7ABC BAYHAM STREET CAMDEN LIFESTYLE

SECTION 73 PROPOSED SCHEME AMENDMENTS
PLANNING APPLICATION
NOVEMBER 2020

This document has been prepared to present the amendments to the consented scheme (Ref: 2018/3647/P) which are predominantly internal and designed to suit the hotel brand.

SOUTH ELEVATION

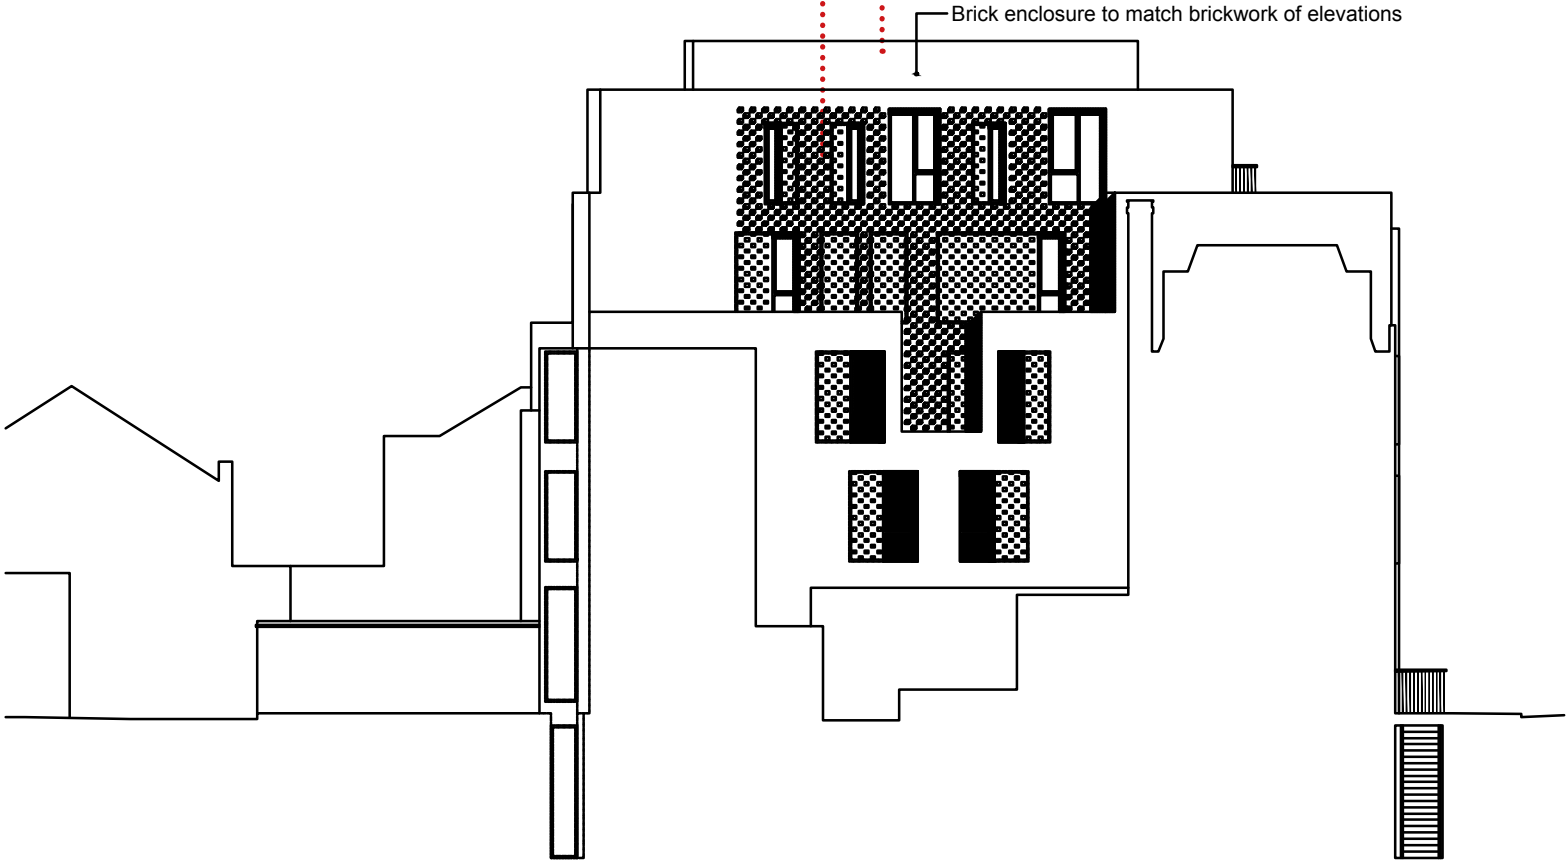
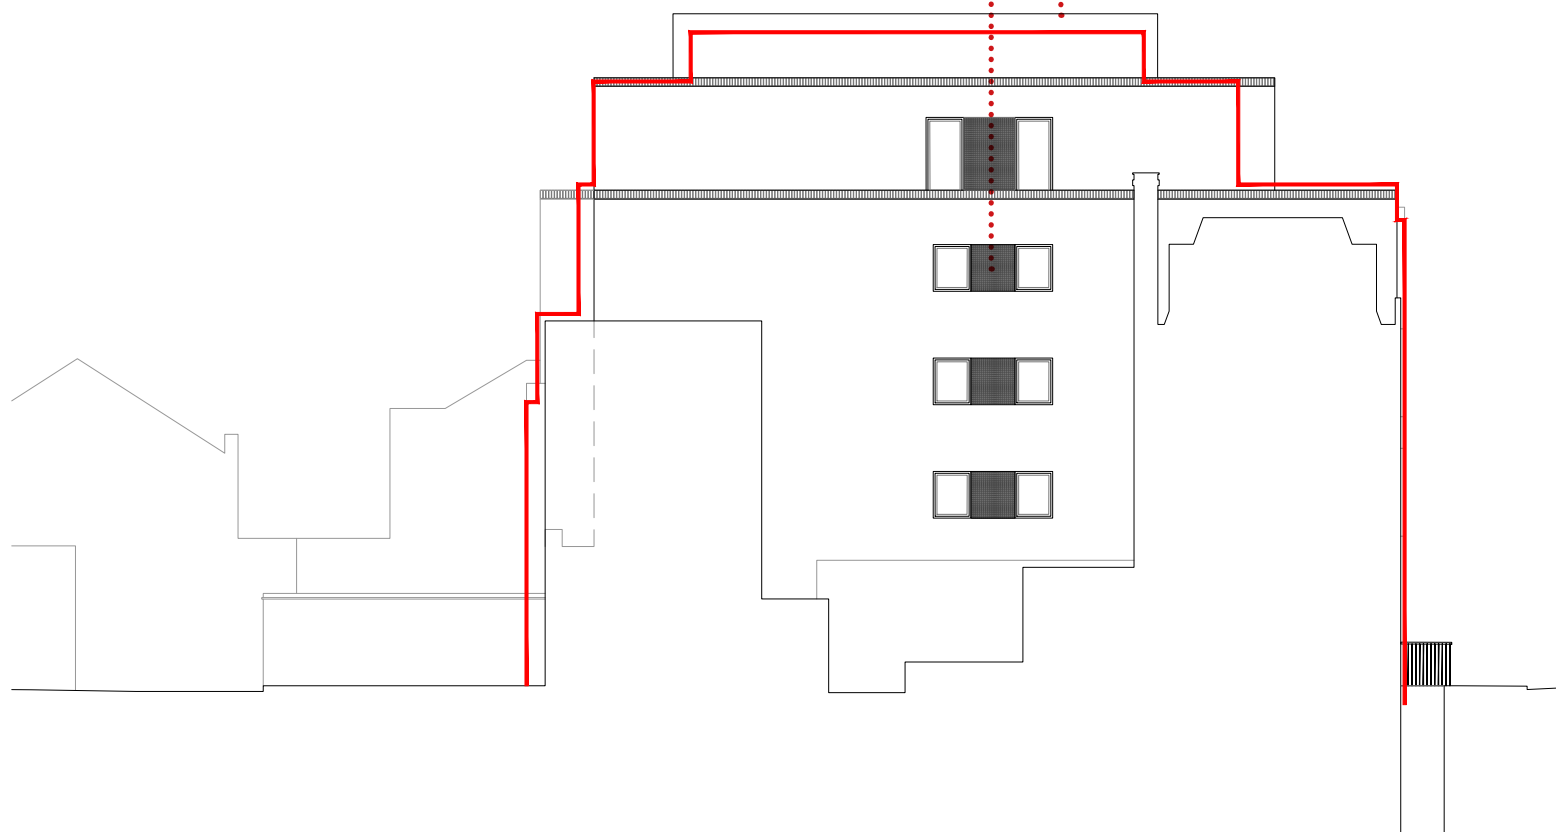
Excessive glazing into
neighbouring courtyard,
impacting on overlooking
issues and maintenance.

Plant screen height not
adequate for servicing of
hotel.
No provision for access to
plant area.

South facade simplified by reducing glazing extent to minimise overlooking and enhance neighbouring courtyard.

Plant Screen height now taller to accommodate for MEP requirements.

- The South facade has been revised to simplify the design features and better sympathise with neighbouring building typologies with an emphasis on improving privacy and reducing overlooking.
- Materiality aligns with existing planning consent.
- Green Walls omitted in response to fire safety.

WEST ELEVATION

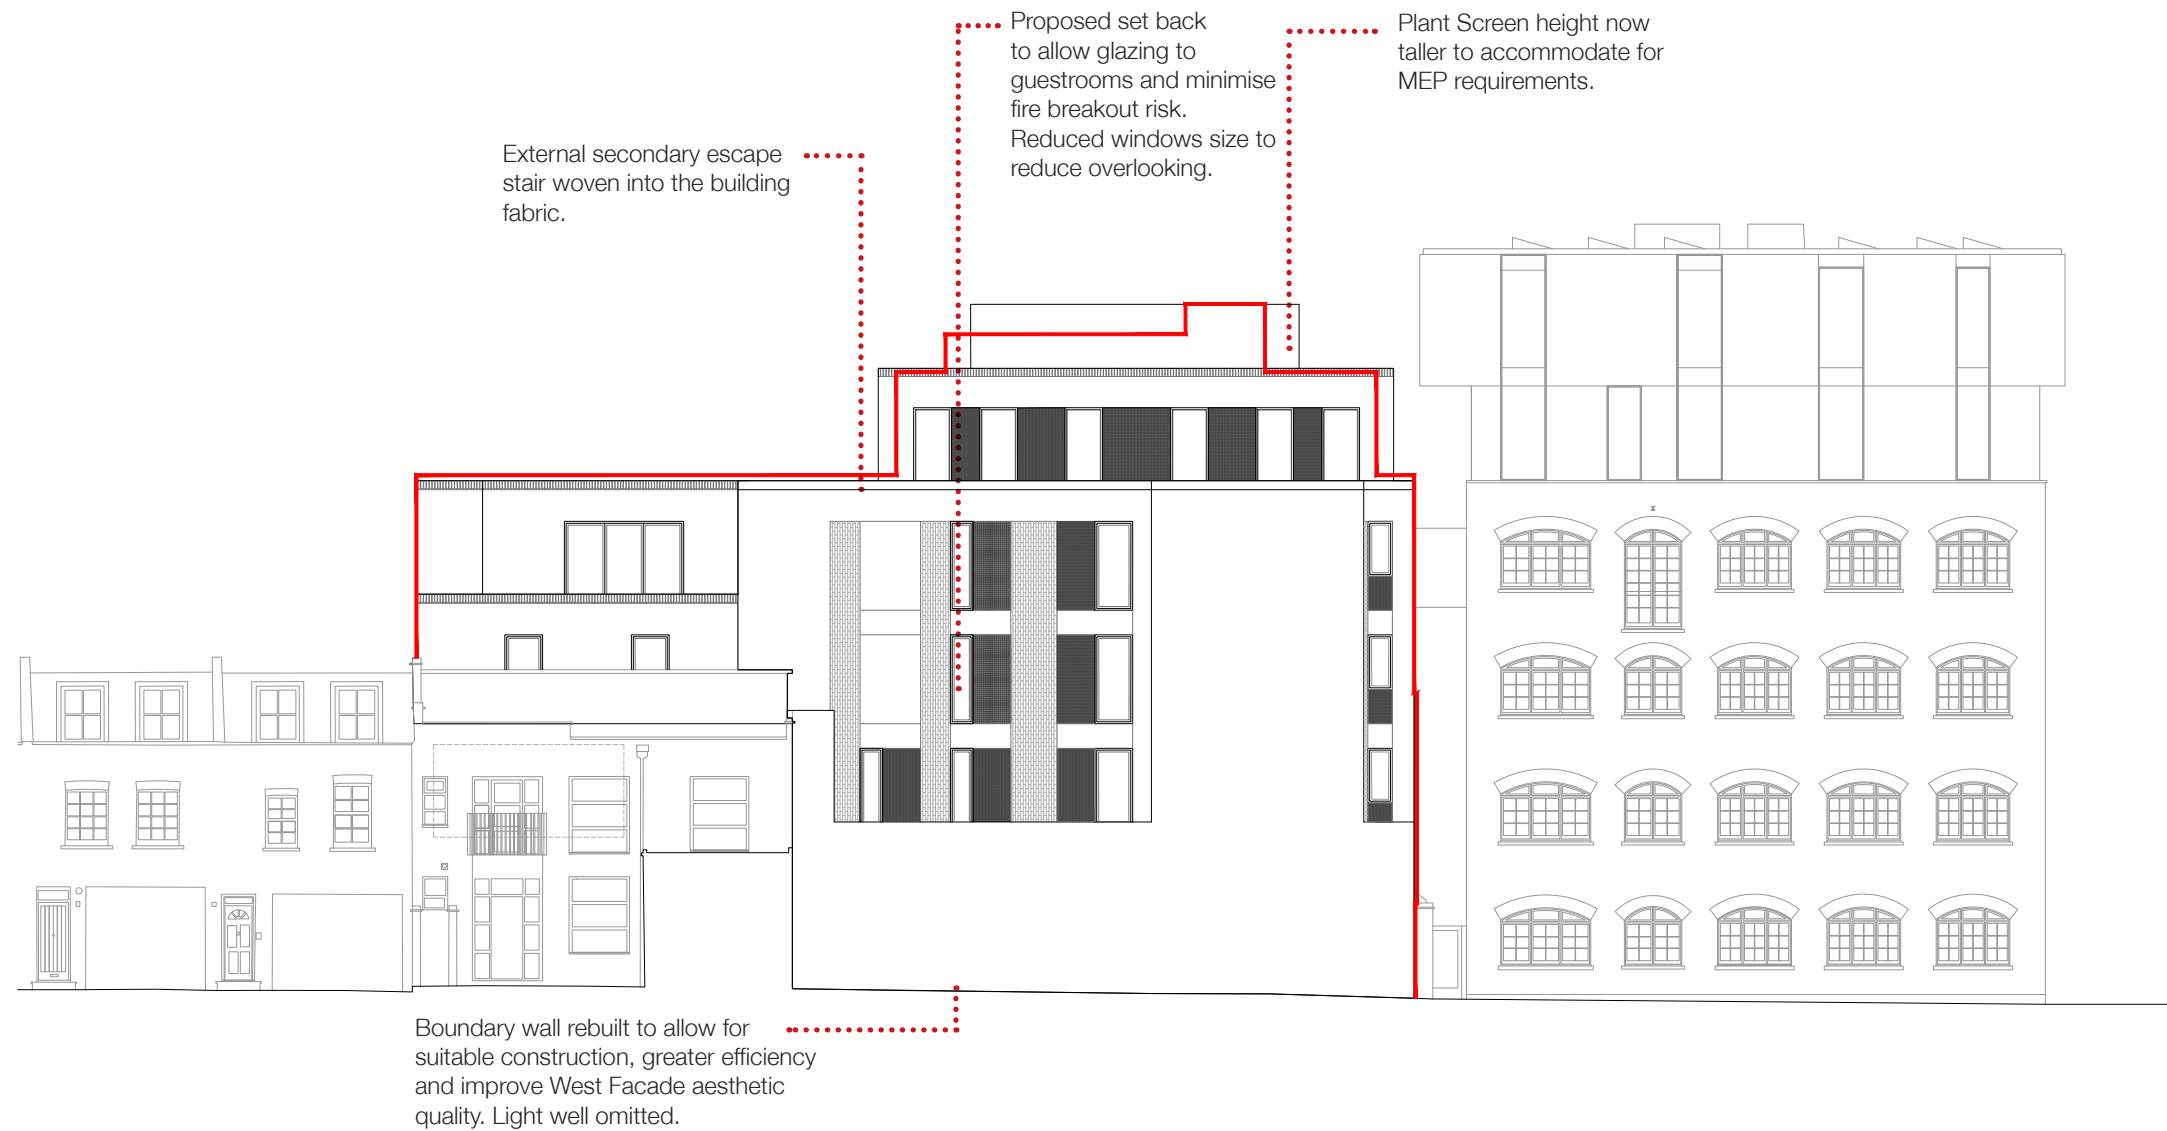
- The West facade has been revised to step away from the boundary to allow glazing to guestrooms and minimise fire breakout risk.
- Materiality aligns with existing planning consent
- Green Walls omitted in response to fire safety.

NORTH ELEVATION

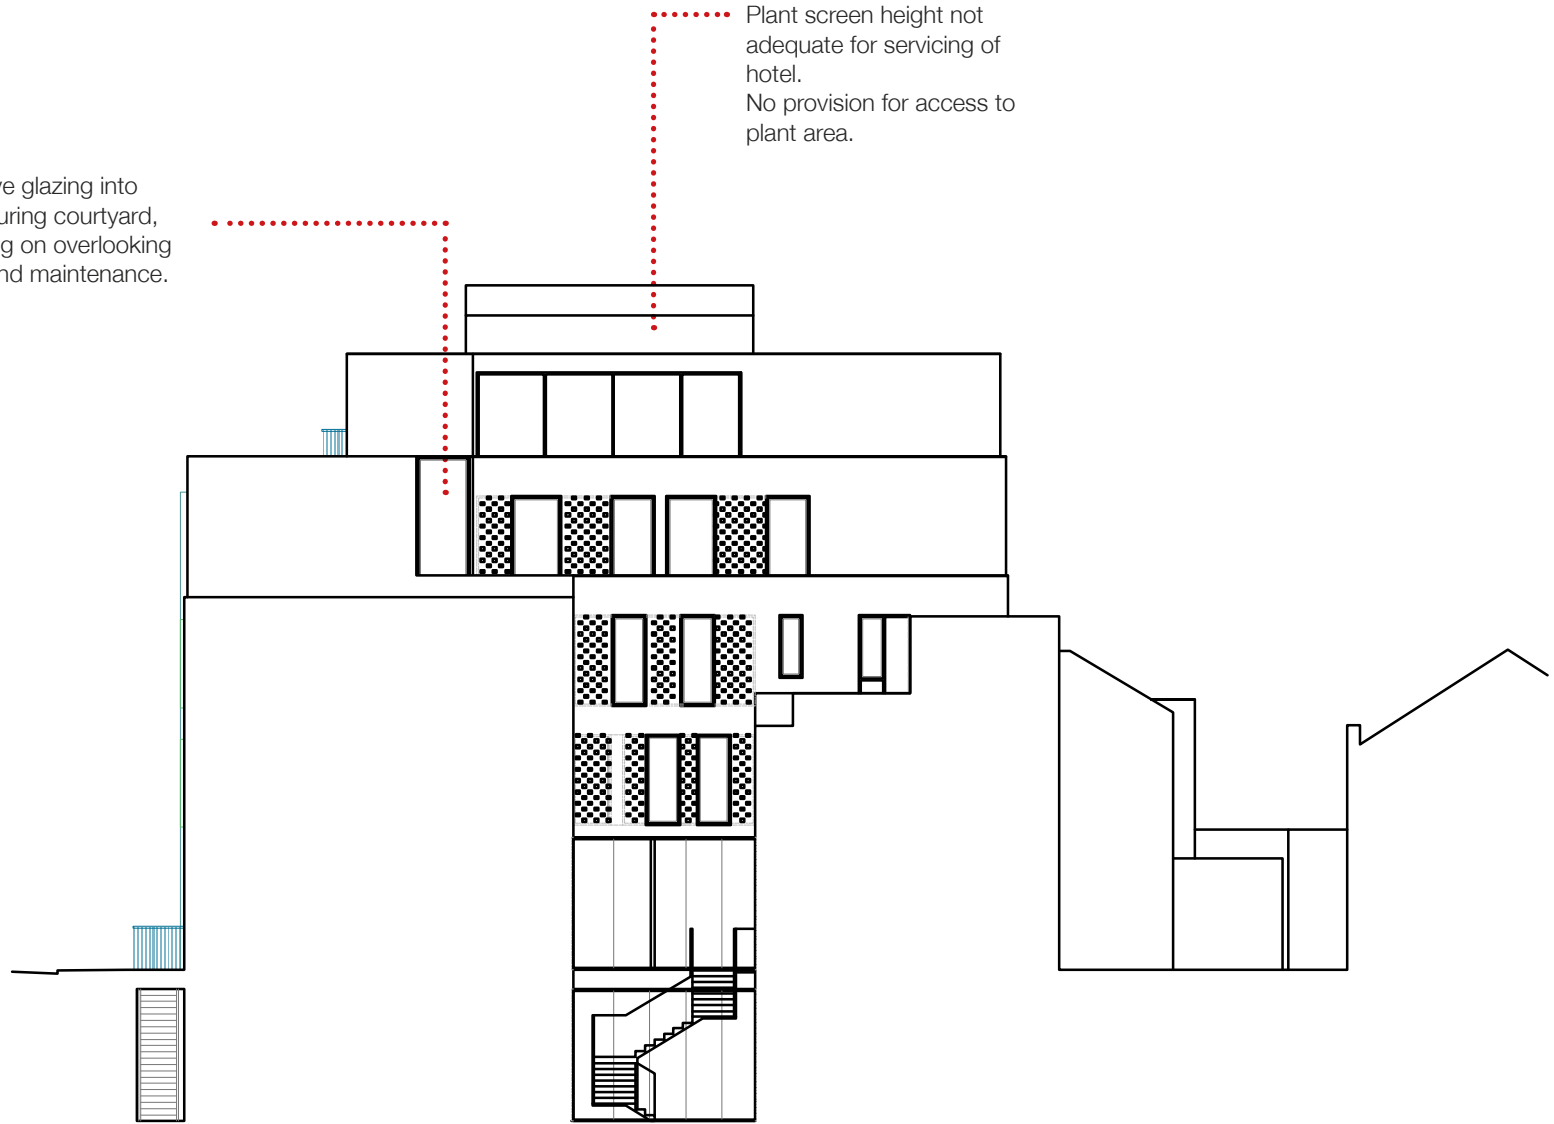
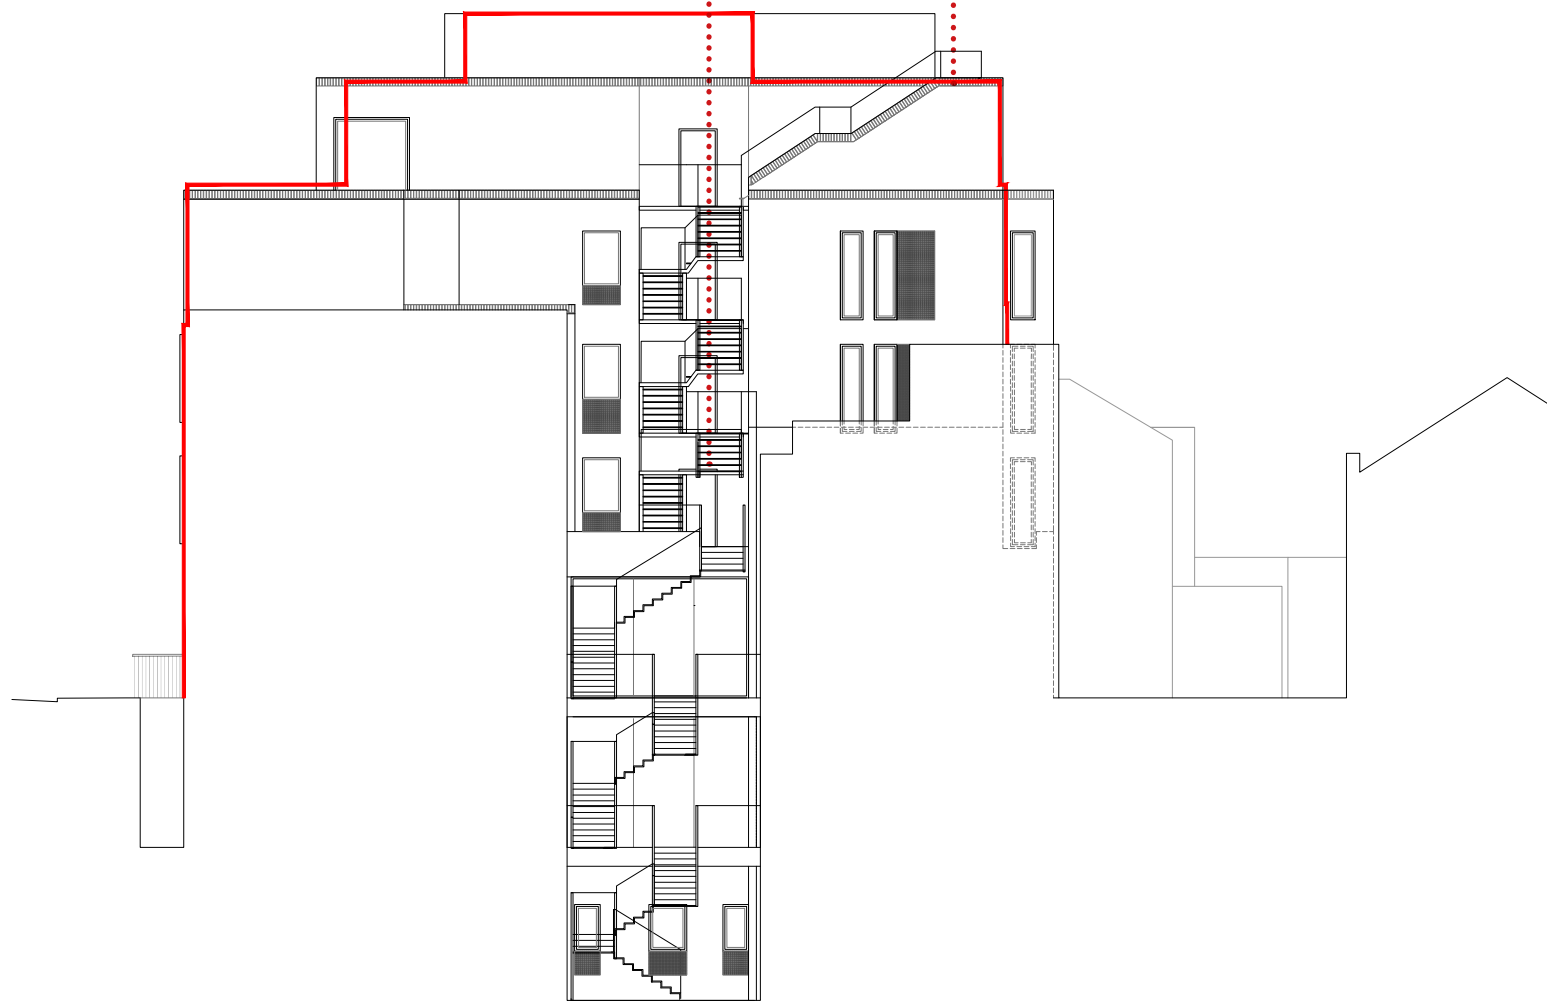
Excessive glazing into
neighbouring courtyard,
impacting on overlooking
issues and maintenance.

Plant screen height not
adequate for servicing of
hotel.
No provision for access to
plant area.

Courtyard Fenestration simplified allowing for less overlooking and more efficient maintenance. Lightwell extended into basement.

External secondary escape stair woven into the building fabric.

- The North facade has been revised to simplify the design features and better sympathise with neighbouring building typologies.
- Courtyard fenestration has been simplified allowing for less overlooking and more efficient maintenance.
- Light well extended to Basement Level allowing light into basement guestrooms.
- Green Walls omitted in response to fire safety.
